**STAFF REPORT**  
**COMMUNITY DEVELOPMENT DEPARTMENT**

HEARING DATE: 7/20/2021  
TO: Mayor & City Council  
FROM: Joseph Dodson, Associate Planner  
208-884-5533  
SUBJECT: FP-2021-0034  
Poiema Subdivision  
LOCATION: The site is generally located at 3727 E. Lake Hazel Road, in the NE ¼ of the NW ¼ of Section 4, Township 2N., Range 1E.

Request for Final Plat consisting of 48 single-family residential building lots, one (1) Church lot, and 8 common lots on 14.88 acres of land in the R-15 zoning district, by Civil Innovations, PLLC.

## A. Preliminary Plat (date: 7/30/2020)

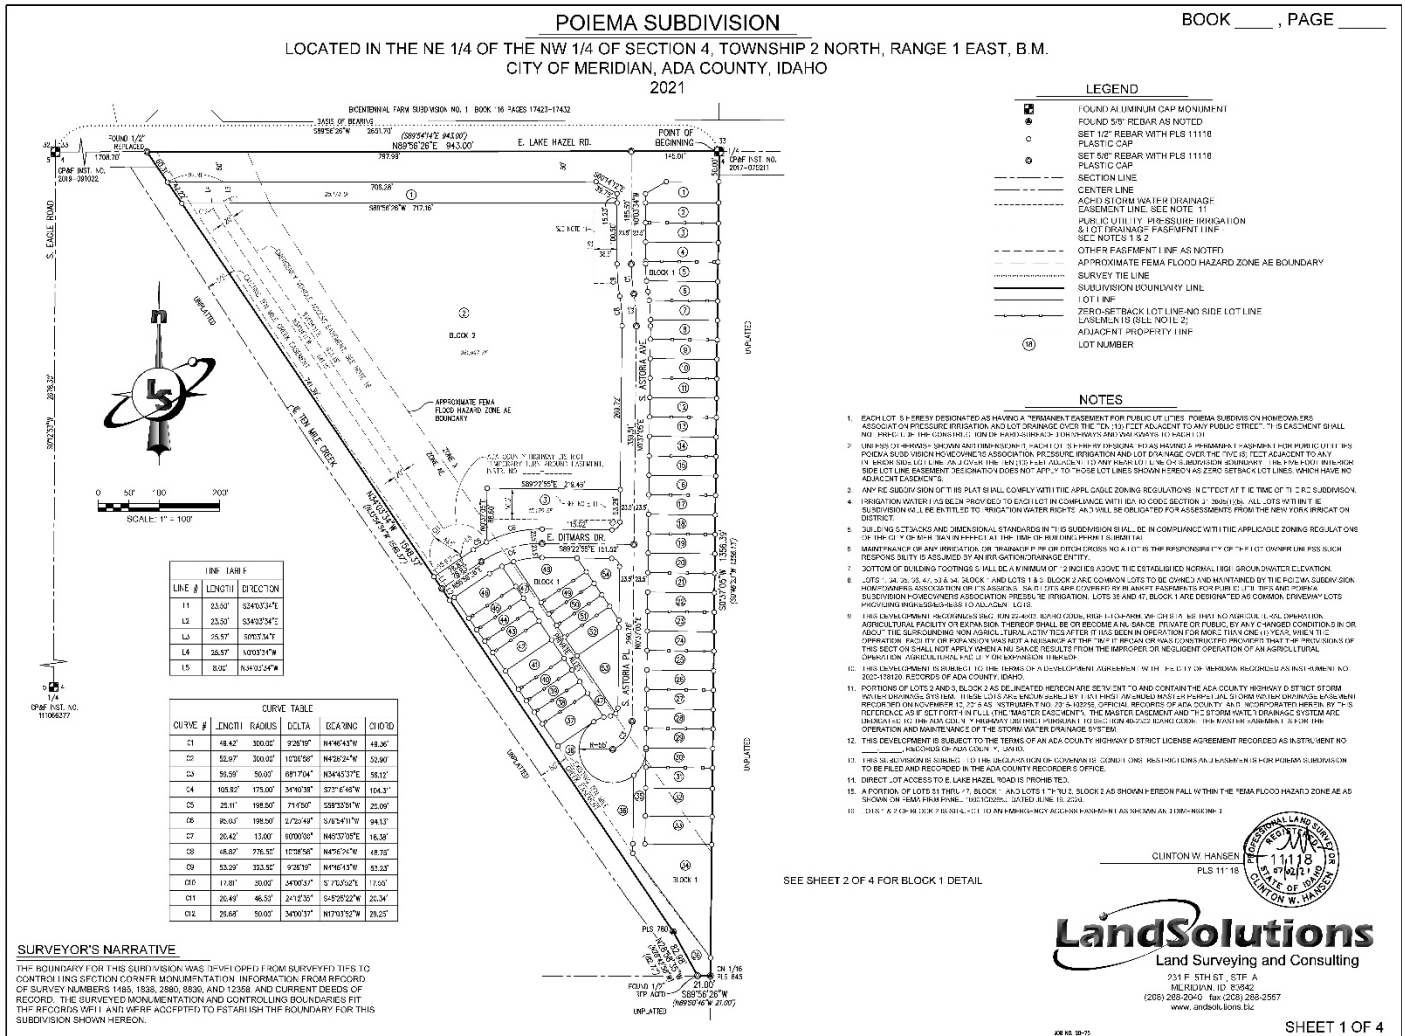
Note: The Applicant Representative, Civil Innovations, revised the proposed stormwater drainage system to be an underground seepage bed instead of a retention pond. This change was made because the stormwater facilities are proposed within the large shared open space lot (Lot 3, Block 2) and cannot count towards the required open space if the drainage system is a retention pond of any kind.

Should ACHD not approve of the proposed seepage bed design, the Applicant may have to revise the plat or request a Development Agreement Modification.

B. Final Plat (date: 7/2/2021)

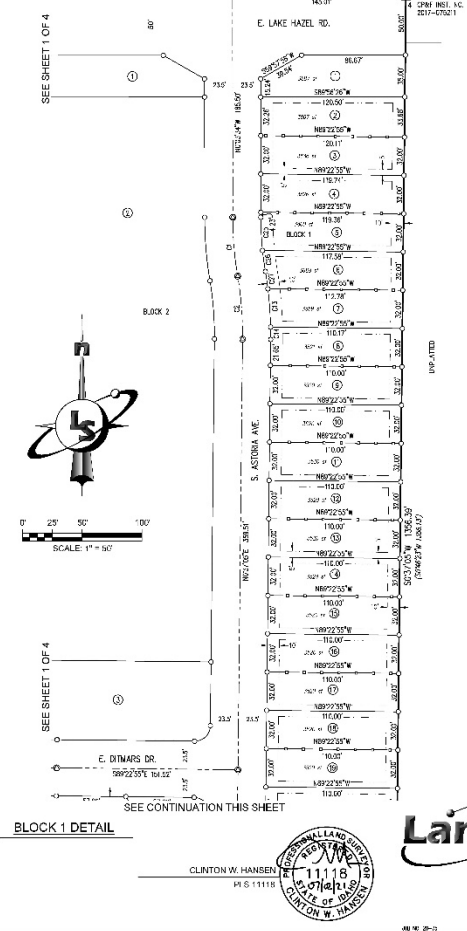
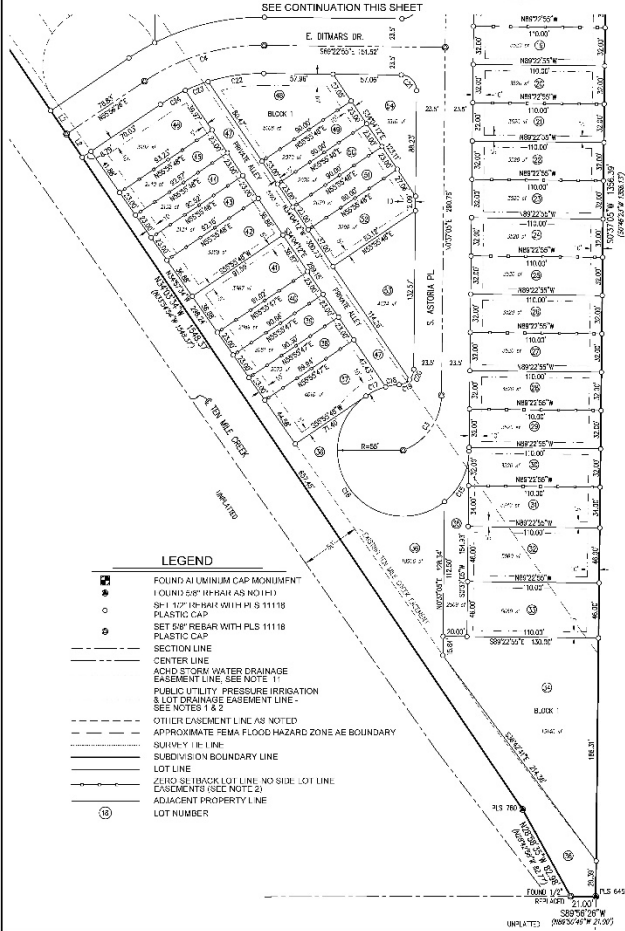
3. Prior to submittal for the City Engineer's signature, have the Certificate of Owners and the accompanying acknowledgement signed and notarized.
4. The final plat shown in Section V.B prepared by Land Solutions, stamped on 07/02/21 by Clinton W. Hansen, is approved with the following revisions:

- a. Note #8: Correct the referenced common lots (remove Lot 34, Block 1 as a common lot per the final plat and construction drawings).
  - b. Note #12: Include recorded instrument number.

- c. Note #16: Include recorded instrument number following easement documentation.
5. The landscape plan shown in Section V.C prepared by Jensen Belts Associates, dated 06/07/21, is approved as submitted.
